Product Change Notification / ALAN-20BLUP482

CCB 4847 Initial Notice: Qualification of ATP7 as an additional assembly site for selected Atmel ATSAM51Jxx and ATSAME5xx device families available in 64L VQFN (9x9x1.0mm) package.

CCB 4847
Pre and Post Change Summary
PCN# ALAN-20BLUP482

ASE Inc. (ASE)

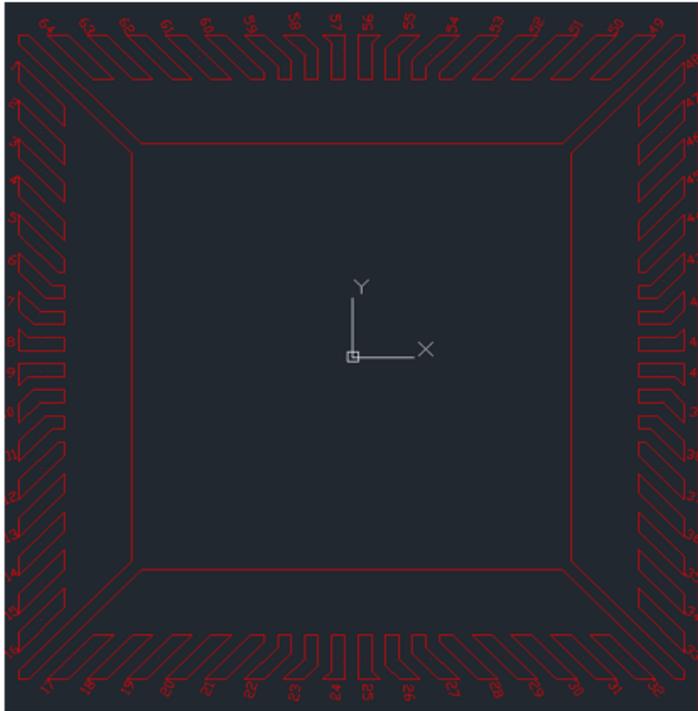
Pre and Post Change Summary

| Material | C194 |
| Paddle size | 193 X 193 |

Amkor Technology Philippines (P3/P4), INC. (ATP7)

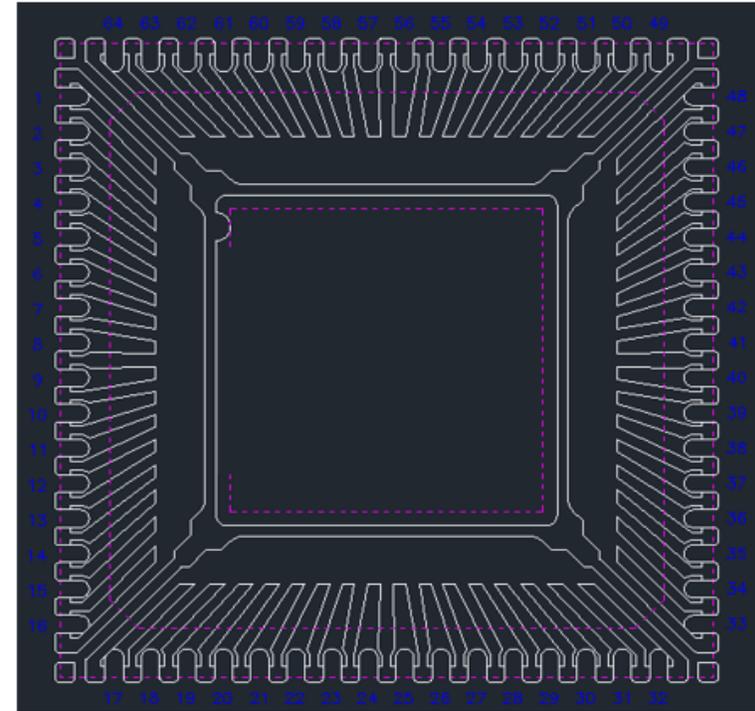
| Material | C194 |
| Paddle size | 197X197 |
